Device	XMC4100/XMC4200
Marking/Step	EES-AA, ES-AA
Package	PG-VQFN-48, PG-LQFP-64

Document ID is **02530AERRA**.

This “Errata Sheet” describes product deviations with respect to the user documentation listed below.

Figure 1 Value update trigger connection between CCU8x and POSIFx

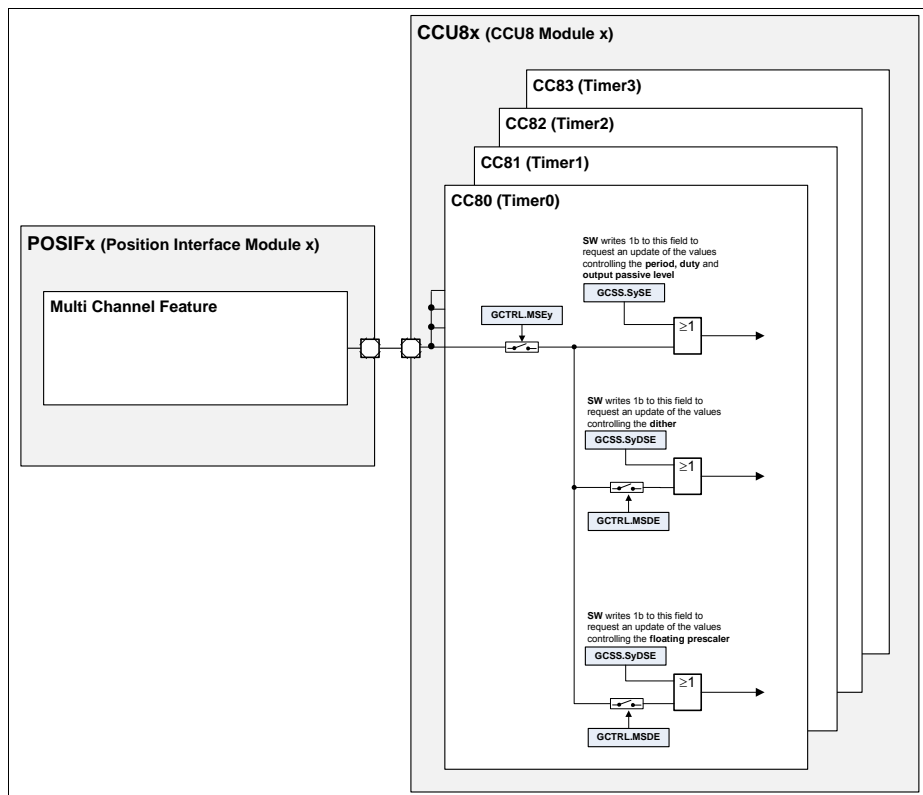
This feature cannot be used with the Timer2 (defined as CC82 in the documentation) of the CCU8x module(s) (more than one CCU8 module can be contained on a specific device).

All the other 3 Timers (defined as CC80, CC81, CC83) inside the CCU8x modul are not affected by this issue.

None

Figure 2 Value update handshake between CCU8x and POSIFx

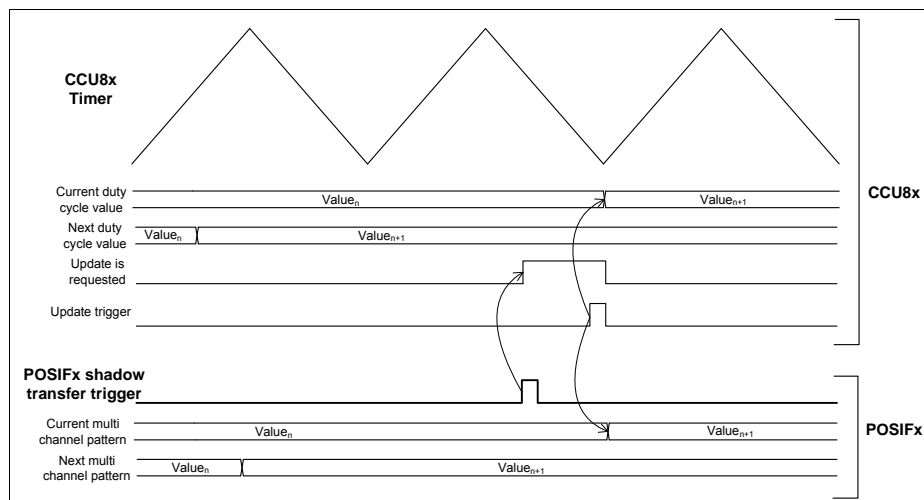
On Figure 2, the SW has updated the next values for the duty cycle on a CCU8x Timer (it can be also for the period, output passive level and clock prescaler). After that it updates also the next value of the multi channel pattern inside the POSIFx module. After that, the POSIF reaches an internal state (dictated by specific conditions) where an update of the values is needed. It generates a trigger signal to the CCU8x Timer to signalize that an update of the duty cycle

value needs to be done. After that timeframe, the POSIFx waits for the handshake trigger of the CCU8x Timer to indicate that an update is going to be performed. At this specific time, both the values of the CCU8x Timer and POSIFx are update completely synchronous.

Figure 3 Parity Checker diagram

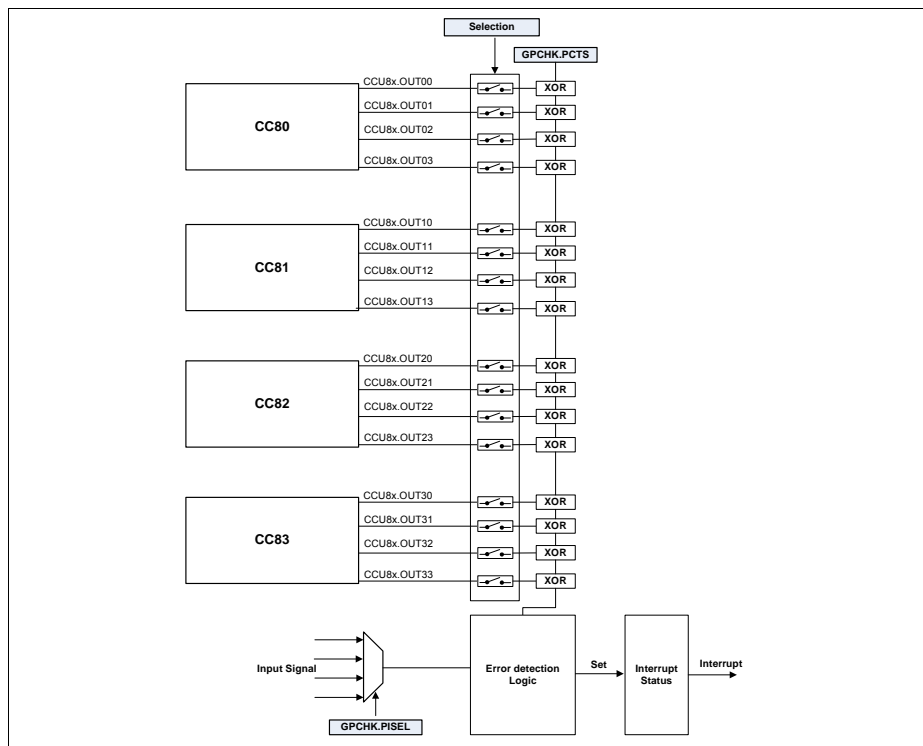
When using the parity checker function, the associated status bitfield, is cleared automatically by hardware in the next PWM cycle whenever an error is not present.

This means that if in the previous PWM cycle an error was detected and one interrupt was triggered, the software needs to read back the status register before the end of the immediately next PWM cycle.

Not ORing the Parity Checker error interrupt with any other interrupt source. With this approach, the software does not need to read back the status information to understand what was the origin of the interrupt - because there is only one source.

Figure 6 PWM output glitch

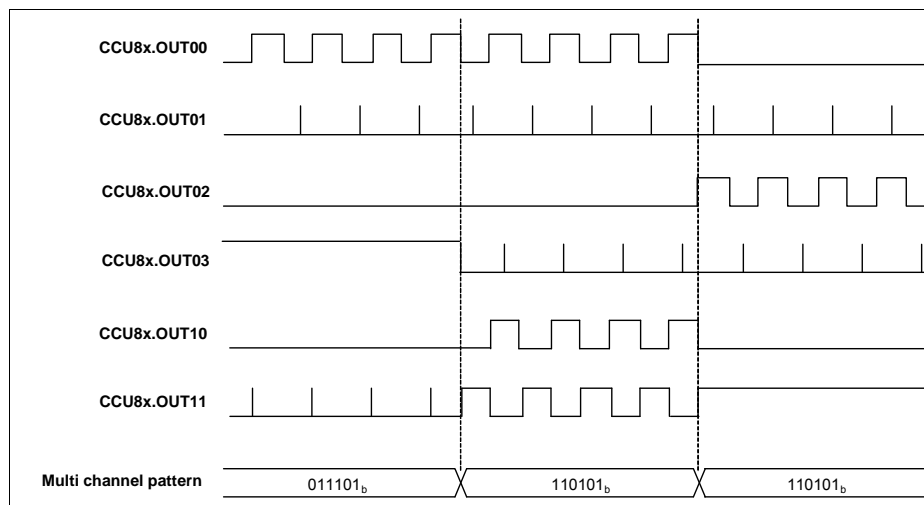
A glitch is present at the PWM outputs whenever the dead time of the specific compare channel is enabled - CC8yDTC.DTE1 and/or CC8yDTC.DTE2 set to 1_B (each compare channel has a separate dead time function) - and the specific multi channel pattern for the channel is 01_B or 10_B.

This glitch only affects the PWM output that is linked to the inverting ST path of each compare channel (non inverting outputs are not affected).

The effect of this glitch can be seen in Figure 3. The duration of the PWM glitch has the same length has the dead time value programmed into the CC8yDC1R.DT1F field (for compare channel 1) or into the CC8yDC1R.DT2F.

To avoid the glitch on the inverting path of the PWM output, one can disable the dead time function before the Multi Channel Pattern is set to 01_B or 10_B. Disabling the dead time of the inverting PWM output can be done by setting:

CC8yDTC.DCEN2 = 0 //if compare channel 1 is being used

```
CC8yDTC.DCEN4 = 0 //if compare channel 2 is being used
```

The dead time needs to be re enabled, before the complementary outputs become modulated at the same time:

Figure 7 Extended Read Back access - example for CCU4 (CCU8 structure is the same)

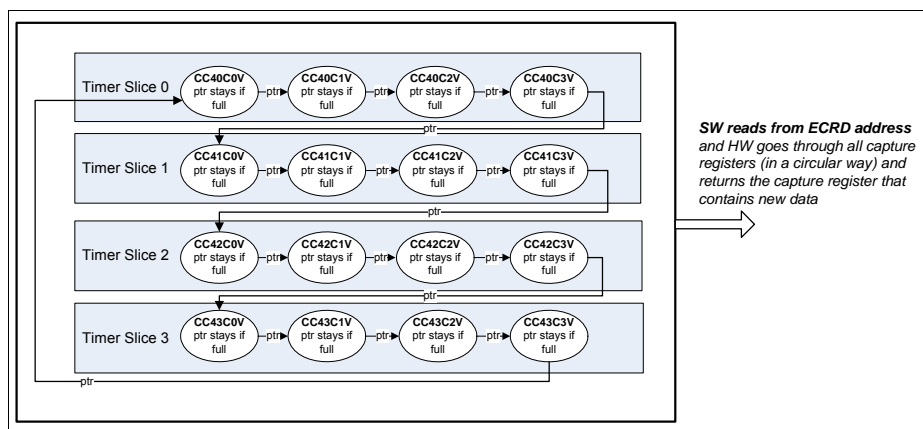
Referring to [Figure 7](#), the hardware every time that the software reads back from the ECRD address, will return the immediately next capture register that contains new data. This is done in a circular access, that contains all the capture registers from the Timer Slices that are working in capture mode.

When using this feature, there is the possibility of losing captured data within a Timer Slice. The data that is lost is always the last captured data within a timer slice, e.g. (with CCU4 nomenclature - same applies to CCU8):

None.

Figure 8 Clock Selection Diagram for CCU4/CCU8

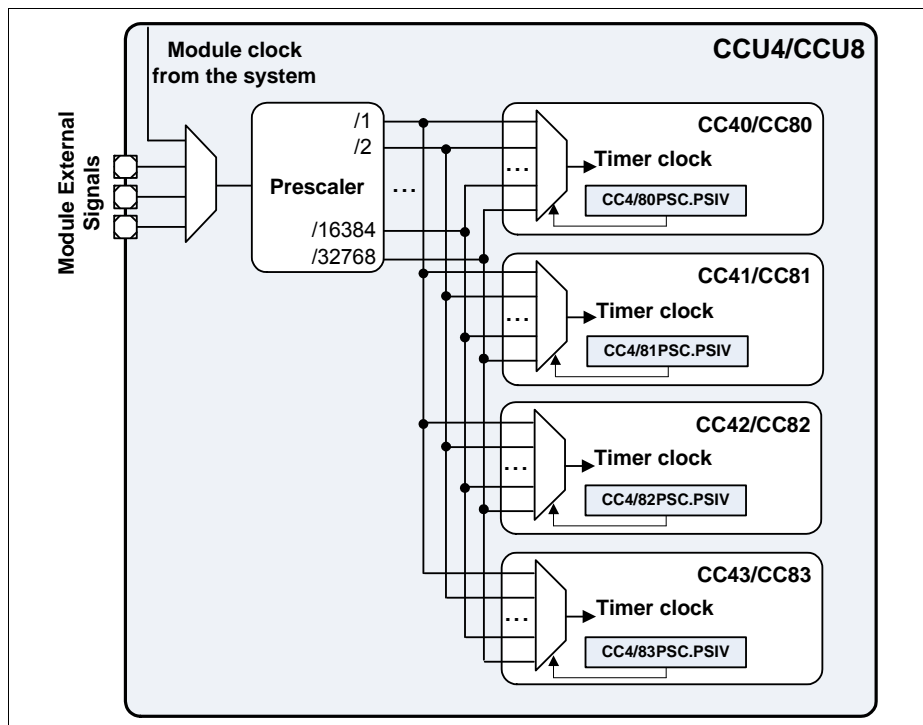
Currently is only possible to use an external signal as Timer Clock when a division ratio of 2 or higher is selected. When no division is selected (divided by 1), the external signal cannot be used.

The user must program the PSIV field of each Timer Slice with a value different from 0000_B - minimum division value is /2.

None.

Figure 11 Collision between signals of the two Source Selectors - valid

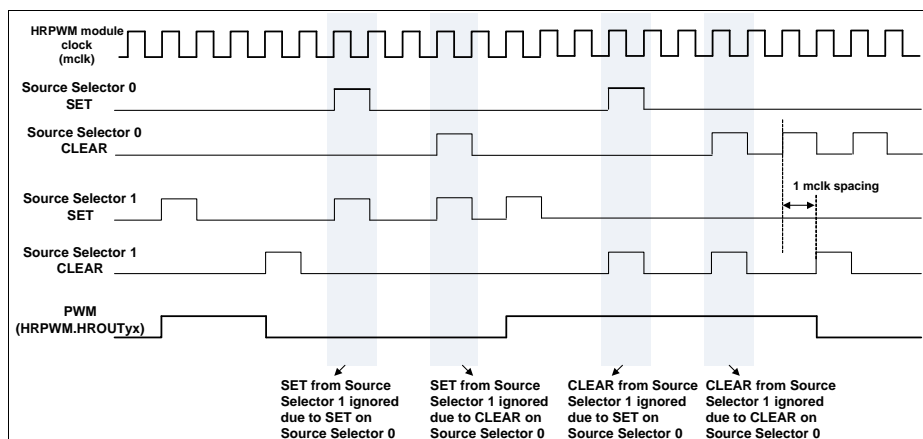
An issue exists whenever the Source Selector 1 is selected ($\text{HRCyST.ST} = 1_B$) and there is a collision between signals from both Source Selectors. A collision is understood has:

If the described condition occurs, then the signal generated by Source Selector 1 is lost and the PWM signal is not handled properly - **Figure 11**.

Ensuring that the signals controlling both Source Selectors are spaced by a minimum of 1 HRPWM module clock cycle. This is indeed only necessary if is currently Source Selector 1 the one selected to control the PWM path ($\text{HRCyST.ST} = 1_B$).

Ensuring that the signals controlling Source Selector 0 are stopped whenever Source Selector 1 the one selected to control the PWM path ($\text{HRCyST.ST} = 1_B$).

Figure 15 Effect of delay on the update of Internal Compare Register with 1 LED column enabled

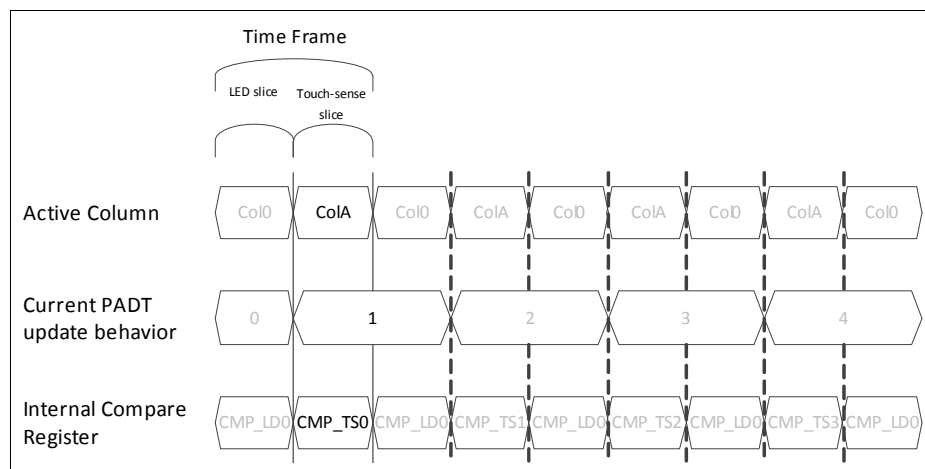
If the number of LED columns enabled is smaller than 2, the delay will affect the activation period of the current active pad. At the beginning of every new Col A, the value of the current PADT's compare register is updated to the internal compare register. However, the delay causes the value of the previous PADT's compare register is updated to the internal compare register instead. This means that the current active pad would be activated with the duration of the previous pad's oscillation window ([Figure 15](#)). In addition to this, when no LEDs

Figure 16 Pad turn 0 prevails for one time slice longer when no LEDs are enabled

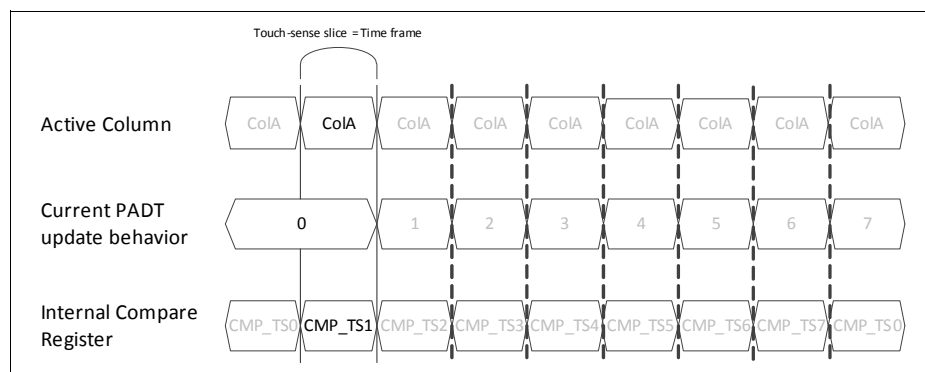
are enabled, pad turn 0 will prevail for one time slice longer before it gets updated (**Figure 16**).

Figure 18 Software workaround demonstration

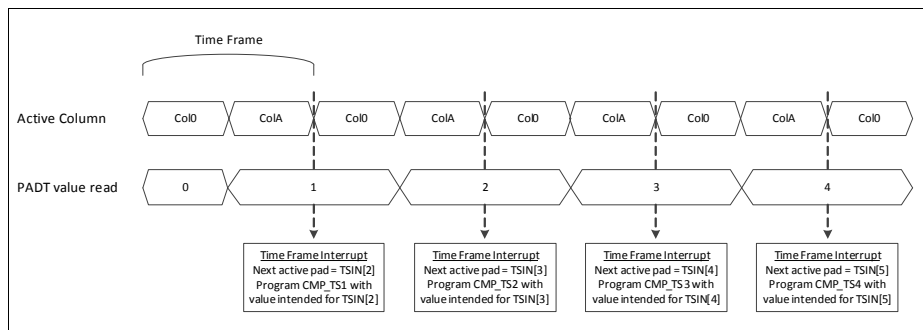
1. At the end of the time frame interrupt service routine, software can prepare for the next active pad turn by programming the CMP_TS[x-1] bit field with the intended compare value for TSIN[x]. As an example, if the next active pad is TSIN[2], program CMP_TS[1] with the compare value intended for TSIN[2] ([Figure 18](#)).

1. During the initialization phase, program the CMP_TS[x] bit fields with the left-shift factored in. Example: CMP_TS[0] for TSIN[1], CMP_TS[1] for TSIN[2], ... CMP[7] for TSIN[0].

Figure 20 Different index signal types

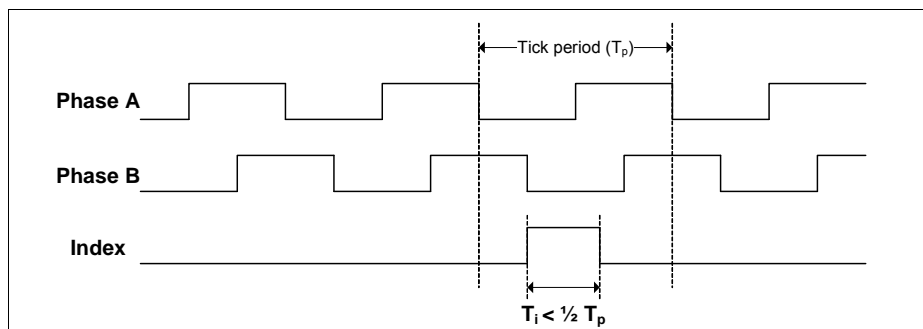
When the index signal is smaller than 1/2 of the tick period, the POSIF module is not able to decode this signal properly, Figure 2 - notice that the reference edge of the index generation in this figure is the falling of Phase B, nevertheless this is an example and depending on the encoder type, this edge may be one of the other three.

Due to this fact it is not possible to use the POSIF to decode these type of signals (index with duration below 1/2 of the tick period).

Figure 21 Index usage workaround - a) Non working solution; b) Working solution

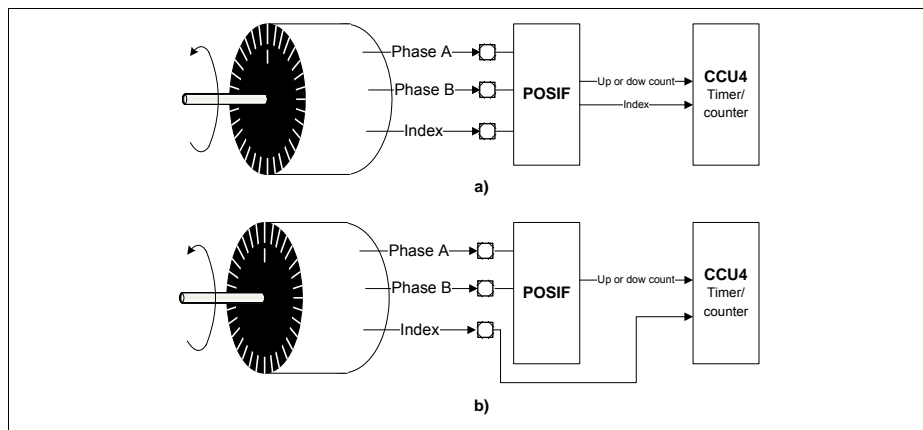
To make usage of the Index signal, when the length of this signal is less than 1/2 of the tick period, one should connect it directly to the specific counter/timer. This connection should be done at port level of the device (e.g. connecting the device port to the specific Timer/Counter(s)), Figure 3.
